Dental Depot Preliminary Development Plan

PL2023-069

June 20, 2023

Staff Analysis

Elevations

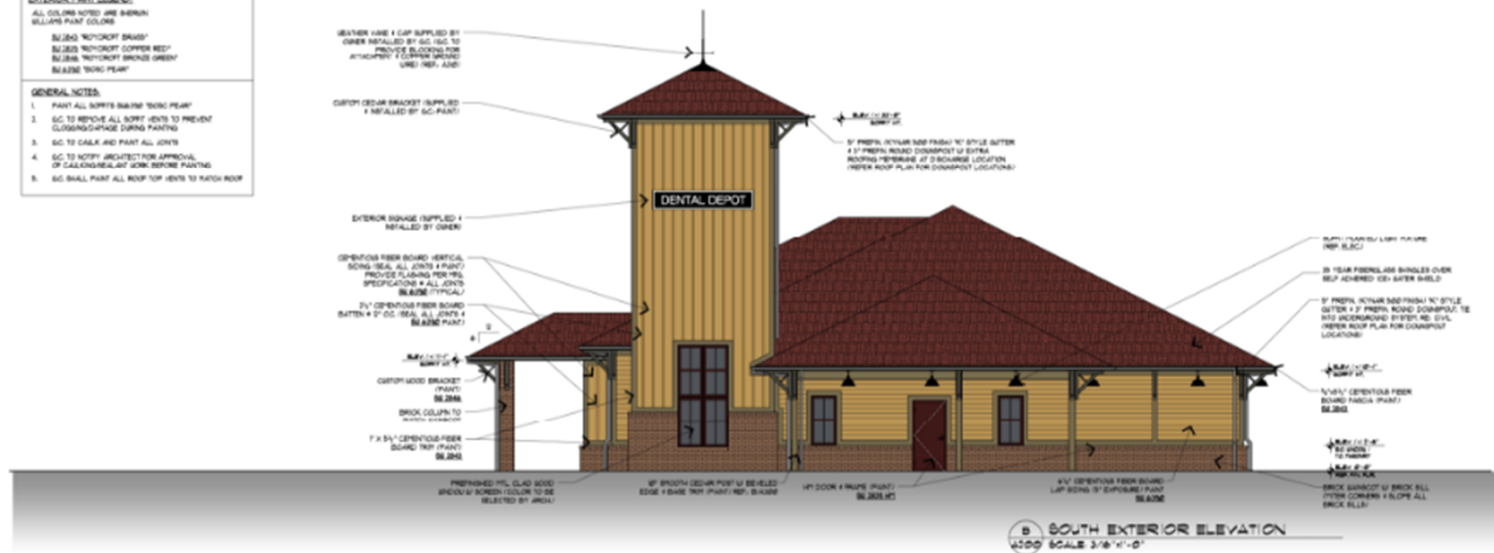
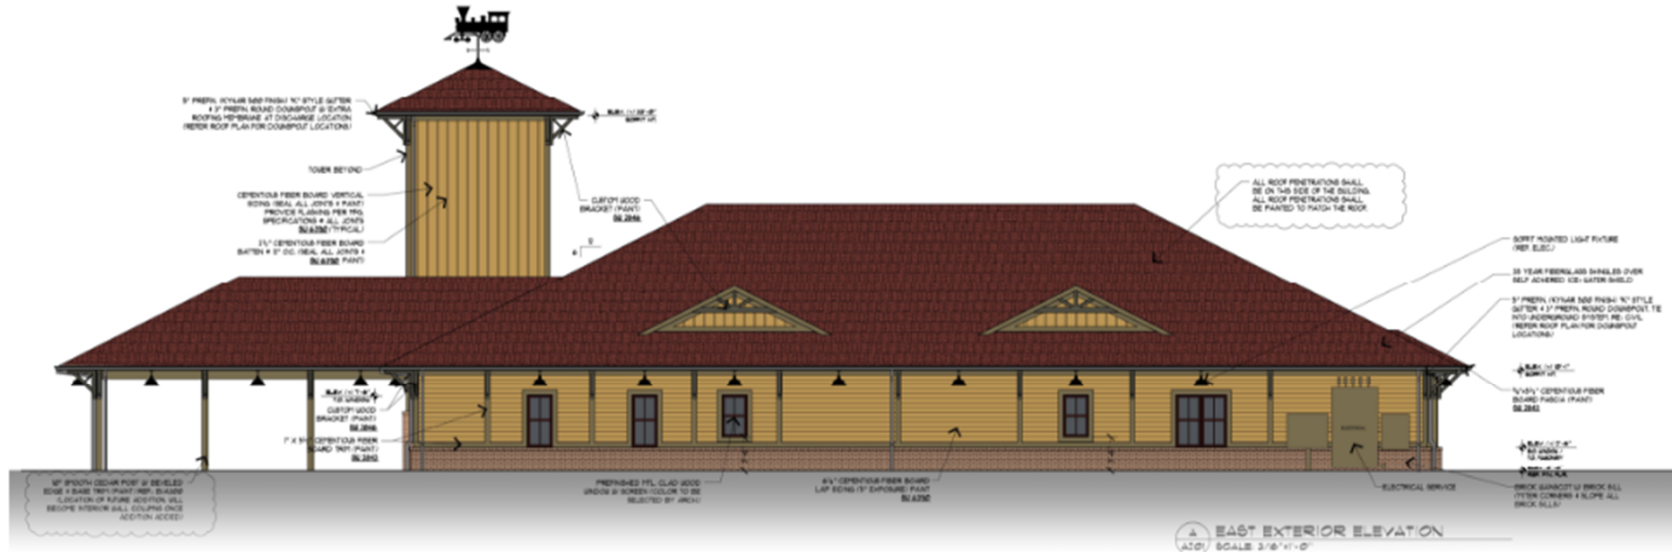
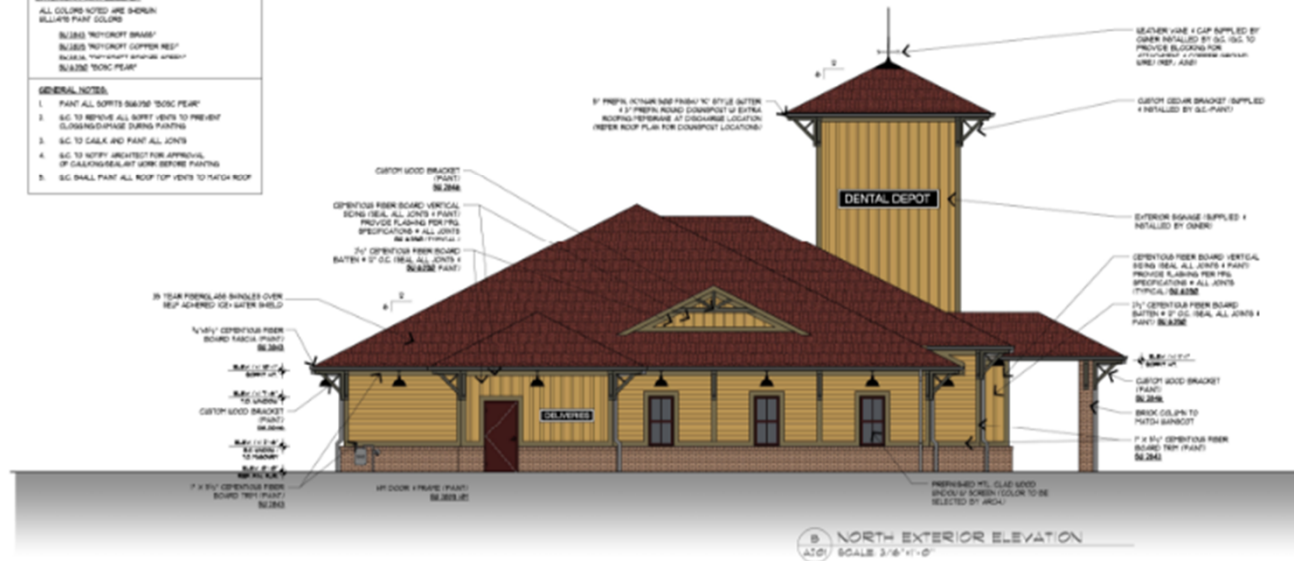
- 37' (building height)

- 21'-6" (water tower height)

3. The use of cedar wood siding as the main material for the proposed water tower element as well as various cedar trim and accent elements on the subject building shall be approved as a conditional material in accordance with the building elevations dated April 10, 2023 and April 21, 2023.

5. No signage or lights shall be located on the water tower located at the southwest corner of the subject site.

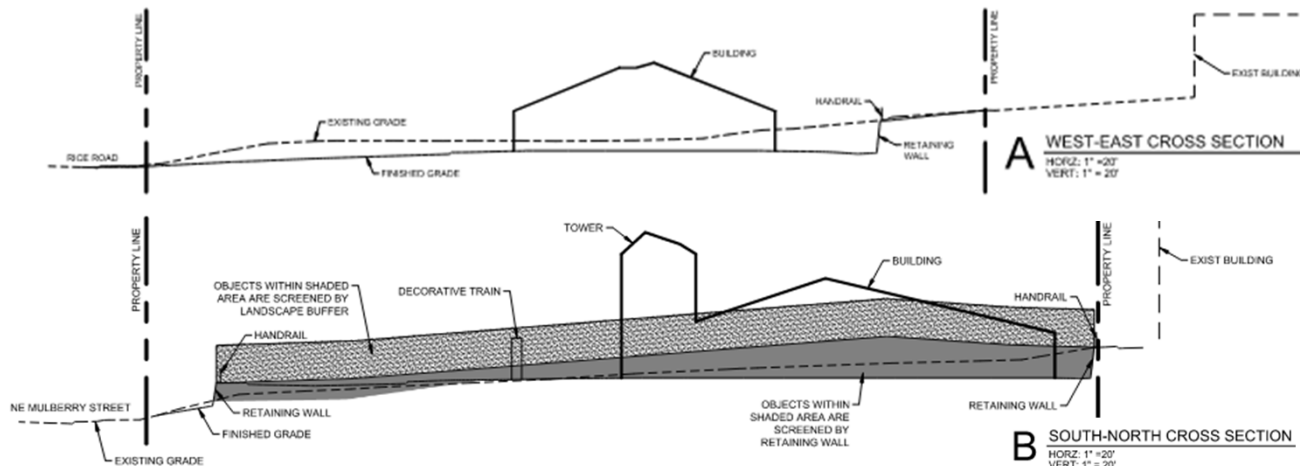
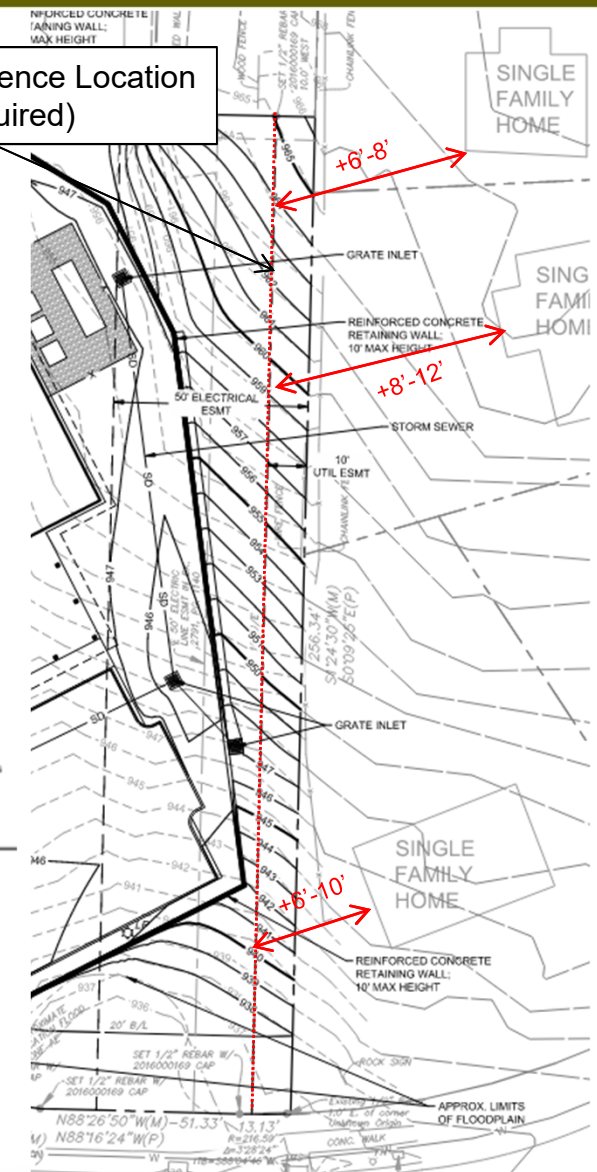
Required –

A 100 percent opaque screen between land uses that are dissimilar in character.

- Six-foot high masonry wall or opaque vinyl fence,
- Low impact vegetation screening planted on both sides of the wall/fence

Proposed –

The applicant has proposed to install the required landscaping screening vegetation without the required six-foot high masonry wall or opaque vinyl fence.

1. A modification shall be granted to eliminate the required six-foot high masonry wall or opaque vinyl fence from the high impact buffer requirement adjacent to the eastern property line.

Sign Package

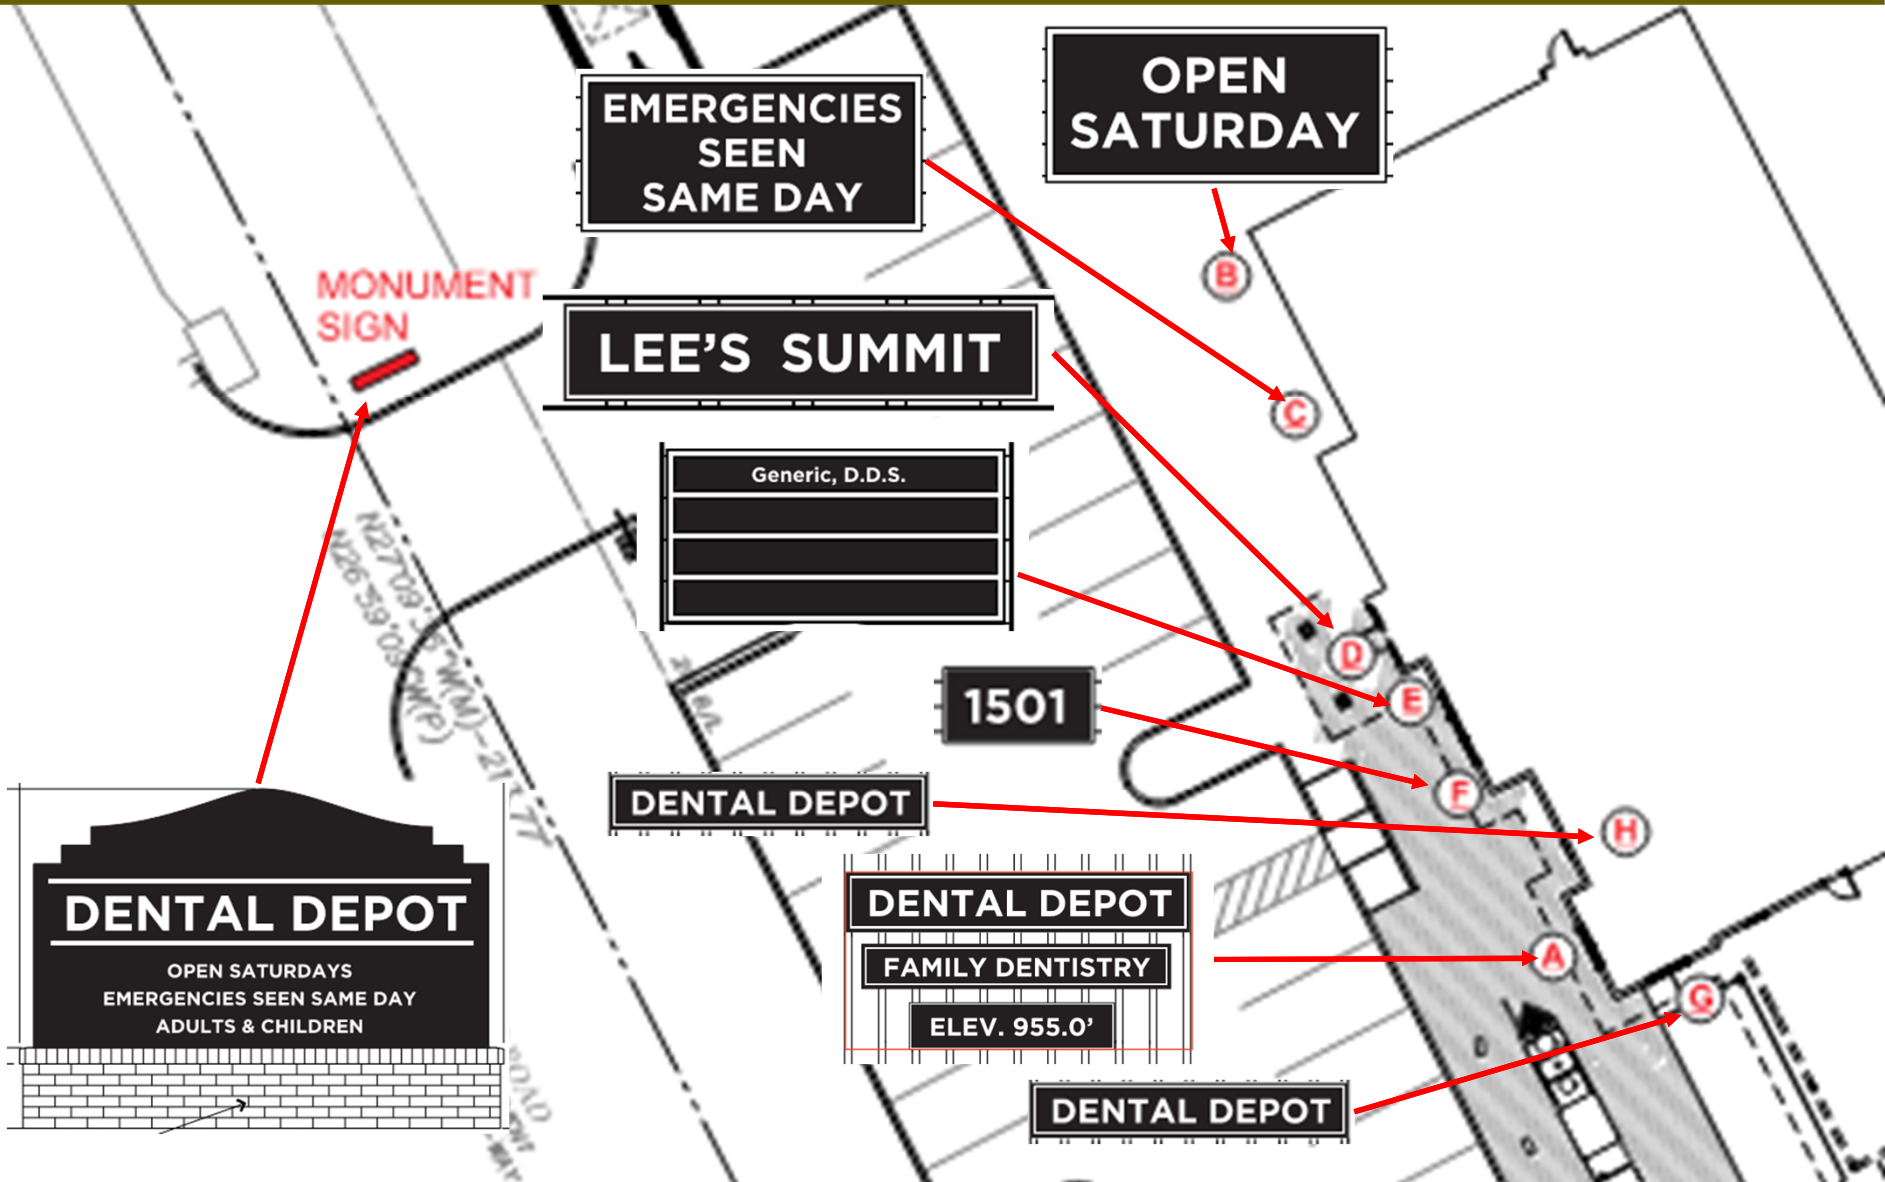
Conditional Material

1'-8" x 10'-0"
(LIGHTED)
16.667 sq ft
27'-9" to
top of sign

2. A modification to the maximum of three (3) wall signs shall be granted to allow eight (8) wall signs as show on the sign specification sheets submitted and uploaded on April 25, 2023.
